SUMMARY

REPRESENTATION

22. Commenting on the Applicant's Environmental Statement – Volume 1 – Chapter 15 Greenhouse Gases

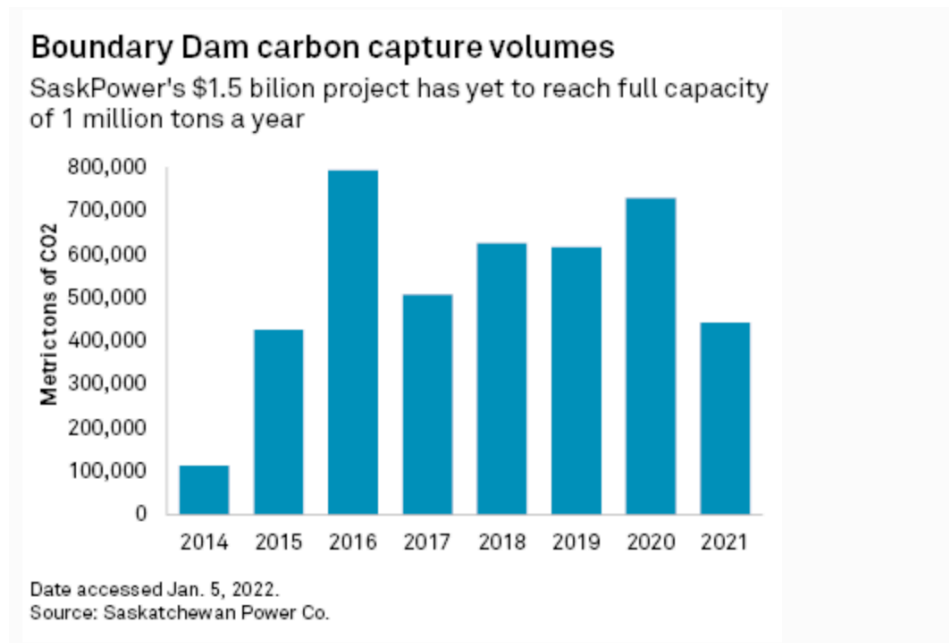
41. Secondly, The Applicant has calculated the forecast annual carbon capture tonnage using a capture efficiency rate of 95%. This is the design target for the system, not a figure based on real world operational experience at scale.
42. The longest-running and largest power station equipped with post-carbon capture in the world is Boundary Dam 3 in Canada. Its operator, Saskpower, set an expectation that it would capture 90% of the carbon dioxide produced by coal burning. Analysis of the reported figures for captured carbon suggest the actual capture rate is below 65%, see the following figure:

43. SaskPower monthly reports going back to early 2020 showed frequent, mostly brief outages due to issues like "wet coal," "plugging," "issues in the powerhouse," "trip," "water cooling issues" and other technical hiccups. Unexpected outages of the power

47. Given the experience at Boundary Dam3 and the Applicant's statement in their EP Variation Request, it is not credible that the Applicant's proposed scheme will produce a long-term carbon capture rate anywhere near 95%. That figure of 95% must be treated as the absolute best case. The examination cannot make an informed recommendation on the application based on the Applicant's 'best-case' and frankly unrealistic performance projections for capture efficiency. We respectfully ask the ExA to require the Applicant to revise their estimate of capture efficiency and to re-calculate the projection for tonnes of carbon dioxide captured.
